**Q2 LMQXB Cold
Mass Module
Assembly Traveler
333643 / Rev. NONE**

**LARGE HADRON COLLIDER
LMQXB
COLD MASS MODULE ASSEMBLY TRAVELER**

**Reference Drawing(s):
Q2 Cold Mass Welded Assembly (ME-390309)
Q2 Module Assembly (ME-369895)**

Sketch TP 03 08 2-01

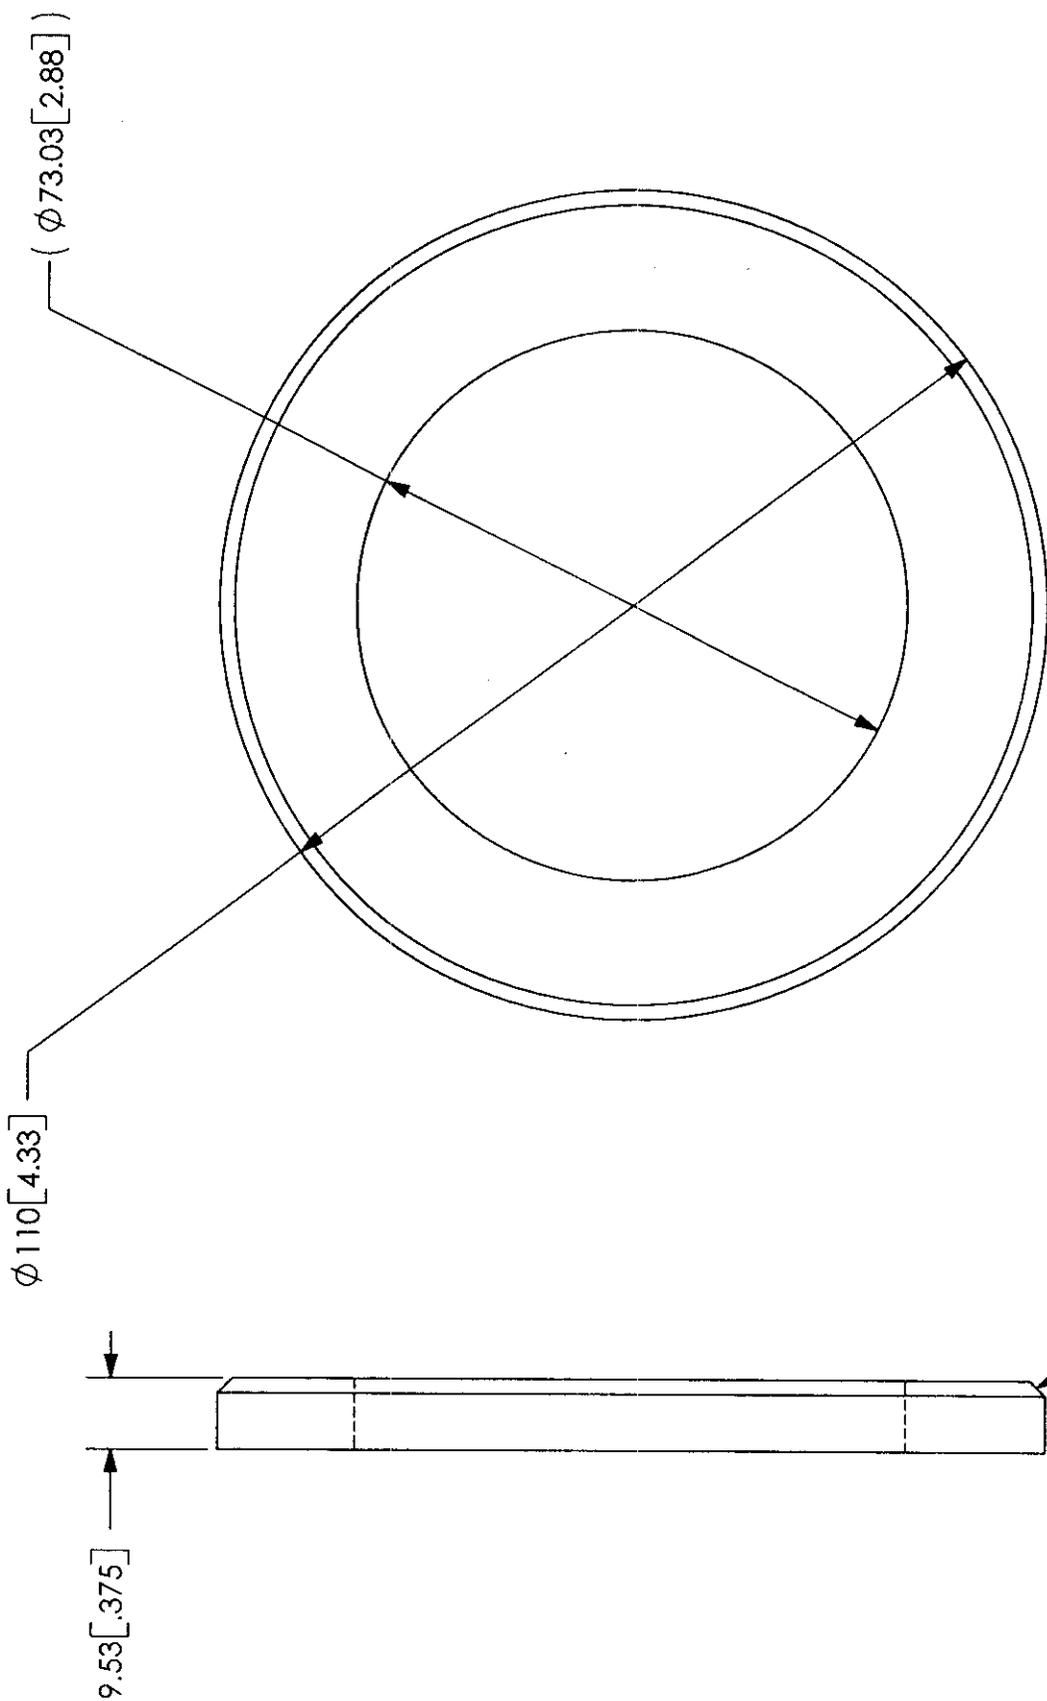
LMQXB02 BEAM TUBE SPACER
08/12/2003
T. PAGE

NOTES:
1) CUT SPACER FROM 390425
2) 2 PCS. REQ'D

Sketch TP030812-02

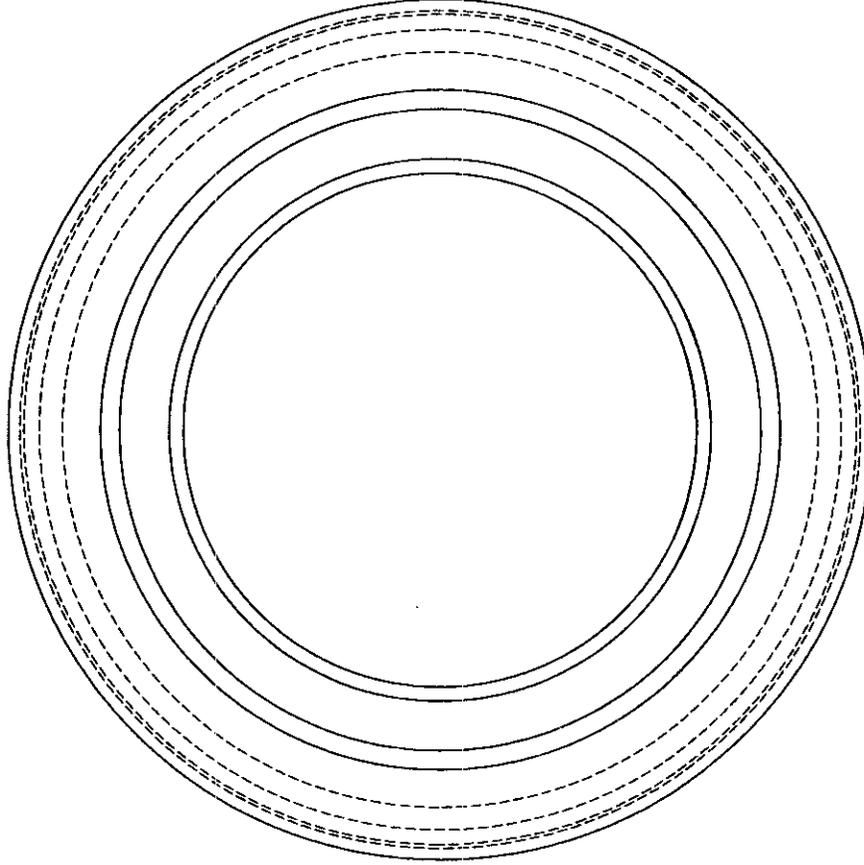
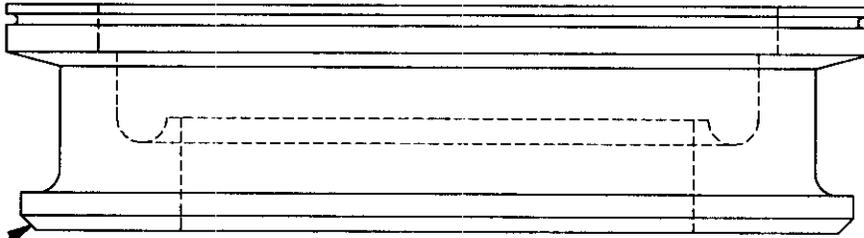
2 mm [0.08 in] x 45° CHAMFER

Beam Tube Flange Modification:
Add Chamfer
T. Page
